# **environmental statement**

related to the  
**PRAIRIE ISLAND  
NUCLEAR GENERATING PLANT**

**NORTHERN STATES POWER COMPANY**

DOCKET Nos. 50-282 50-306

Fig. III-12. Prairie Island Nuclear Generating Plant  
Liquid Waste Disposal System

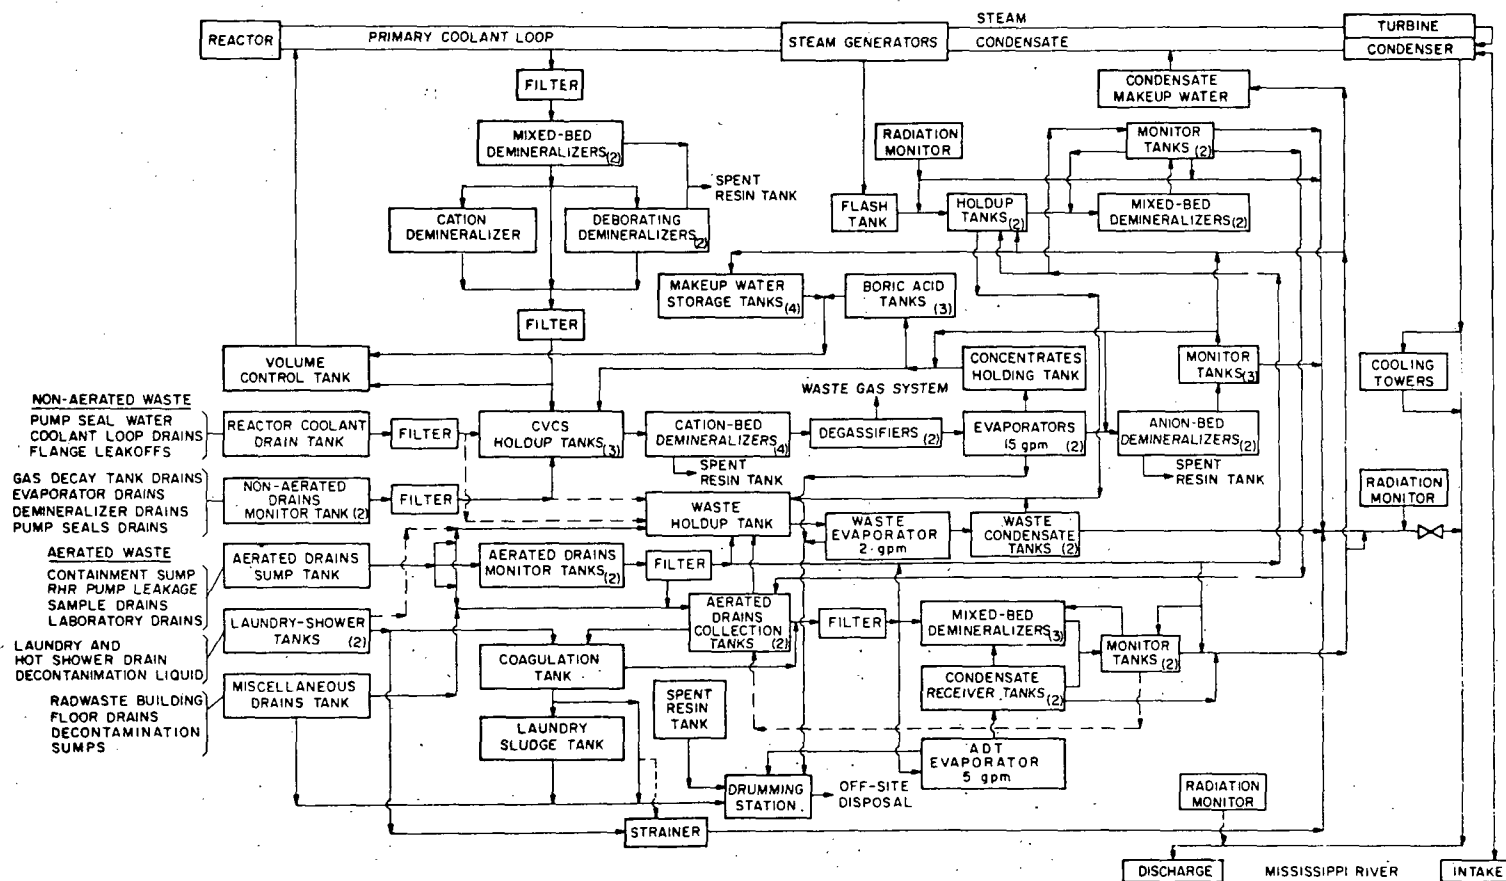
Figure III-12, Page III-26, shows radwaste laundry water directed to the septic tanks. This water may contain radioactive material, but is not monitored since it is withdrawn downstream from the radiation monitor. Also, the text indicates that no radwastes are directed to the septic tanks. This apparent discrepancy should be resolved in the final statement. Further, the discharge of nutrients into a eutrophic area should be discouraged.

mentioned in a discussion of a fourth independent liquid radwaste treatment system (page III-28). The Applicant has stated<sup>1</sup> that this will not be done and Figure III-12, page III-26, has been appropriately modified for consistency with this intention. Thus the statements elsewhere (pp. III-41, IV-5, and V-11) that no radioactive waste will be processed in the sanitary sewage disposal system are valid.

12. Laundry Water to Septic Tank, Figure III-12 corrected (MPCA, p. C-34; and EPA, p. C-66)	III-26
13. Gaseous Doses (Table V-4, p. V-31 recalculated)	E-1, also XII.A.28
